Range SA Large Regional	Model W100	N° T.I. 10_2025
Serial Number 51121274	Subject NEW NON-RETURN VALVE SOLUTION	WITTENBORG

Range SA Large Regional	Model W100	N° T.I. 10_2025
Serial Number 51121274	Subject NEW NON-RETURN VALVE SOLUTION	WITTENBORG

New non return valve solution

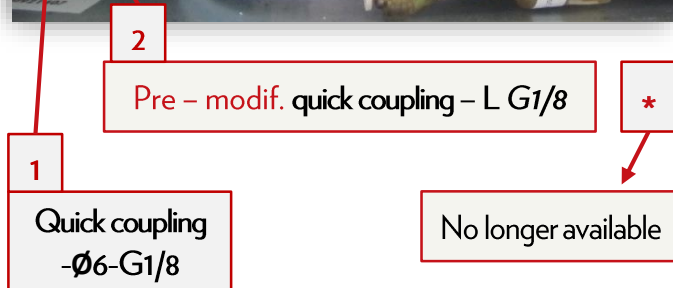
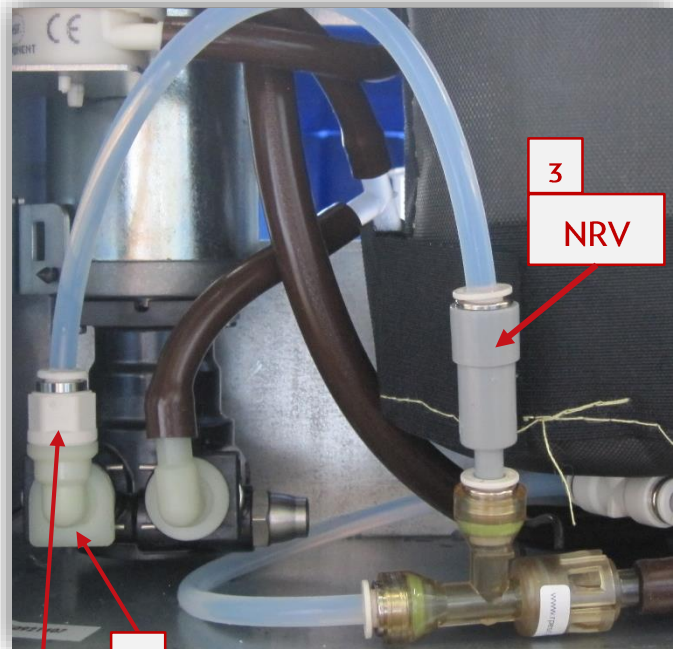
starting from S/N **51121274**, machines are equipped with a **new non return valve** solution, which involves the modification of some components; the lengths of the hoses remain unchanged.

The **new non-return valve (3)** is housed in the **modified quick coupling - L G1/4 (2)**

For machines previous to **S/N** above, it is possible to switch to the **new** solution by ordering the **"quick coupling with non-return valve"** KIT (spare code: **267581**), composed of the components listed in the table **"New non-return valve solution"** (see below).

- ✓ for machines previous to **S/N** above it is not required to replace the **NRV**.
- ✓ The **pre -modification NRV** and the **pre -modification quick coupling Ø6-G1/8 PPSU** are still available, while the **quick coupling - L G1/4** (code **266964**) in the **pre-modification** version (G1/8) is no longer available.
- ✓ If the **quick coupling - L G1/8** (no longer available) is required, it is necessary to order the **KIT** indicated above.
